SERVICE BULLETIN: JSB 003-1

Subject: Jabiru J400/J200 Door Bolts

Jabiru J400, J200, J430, J230, J450 and J250 models

Figure 1. Hinge Bolt Detail

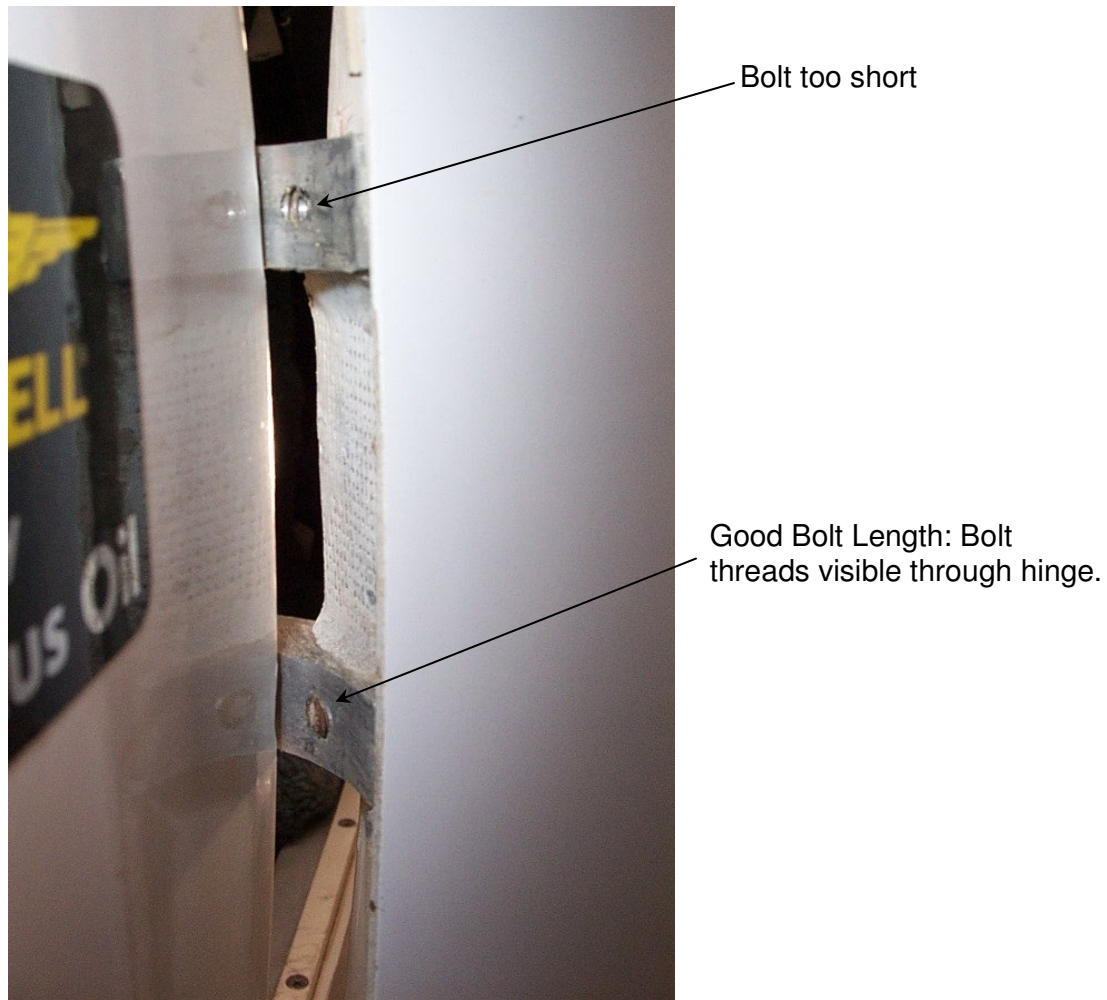
Some Builders of Jabiru J200/J400 series aircraft (All Jabiru Fuselages with 3 doors) have found that the bolts attaching the doors to the hinges are too short to positively engage the threads tapped in the aluminium hinges.

During the aircraft's next inspection, the hinges should be visually inspected. Refer to Figure 1 below.

If one or more of the attachment bolts are short, as shown in the top bolt above, they are to be replaced with a longer item. The attachment bolts are 1/4" UNC Socket Head Cap screws.
